Application ref: 2022/5620/PRE
Contact: Ewan Campbell
Tel: +44 20 7974 5458
Email: Ewan.Campbell@camden.gov.uk
Date: 13/04/2023

Pre-application Medium Development Pre-application Advice Issued

**Stables Building Former Hampstead Police Station
26 Rosslyn Hill
London
NW3 1PD**

Proposal: Change of use of the existing annex of stables to Class C3 (residential) to provide additional accommodation to approved house in stables block, plus a basement extension, mansard roof extension with dormer windows, link extension to stables, PV panels, cycle parking, hard and soft landscaping to the front.

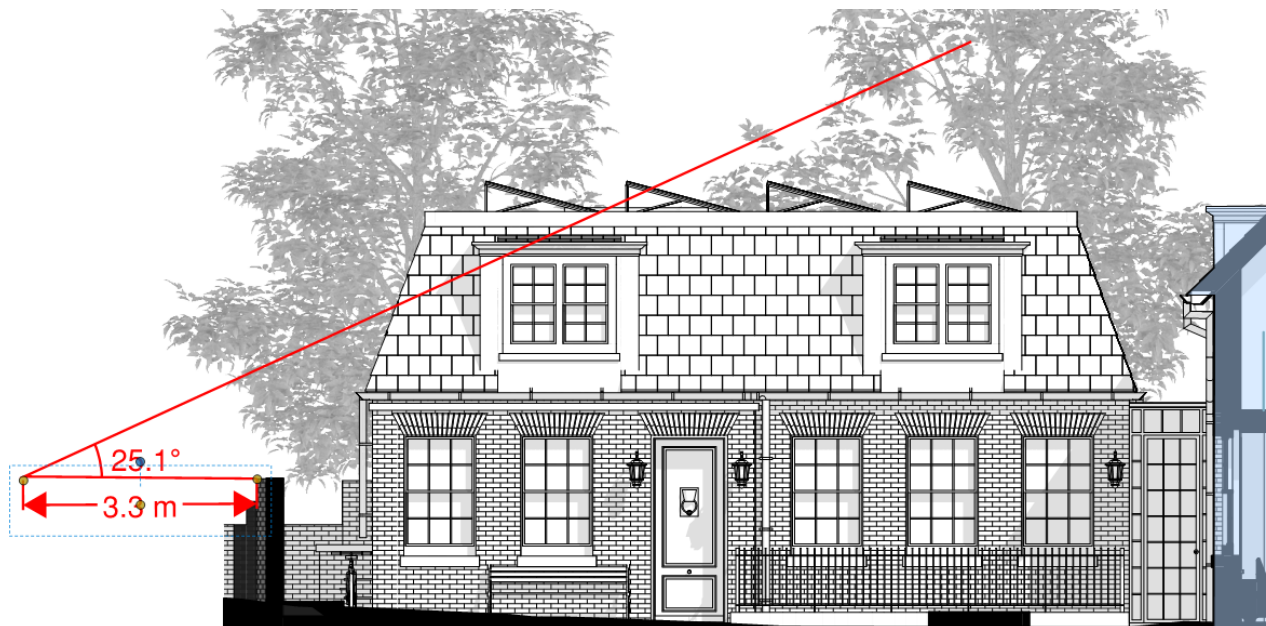
The policy requires the basement to remain subordinate to the host property and not contribute to overdevelopment. Even though the annex is being demolished and replaced with a building that is bigger in footprint, the proposed basement still appears to meet the criteria f to l of policy A5 of the 2017 Local Plan when tested against the footprint of the original annex building.

Whilst the size of the annex building is considered unacceptable and will need to be reduced in any application, overall the basement does not appear excessive in the context of the requirements of policy A5. However because of the development scale having to be reduced, the basement will undoubtedly have to be reduced slightly.

It is important to note that in order for the basement to be fully acceptable, a full BIA including a Basement Construction Plan will need to support the application which will then be independently assessed by Campbell Reith.
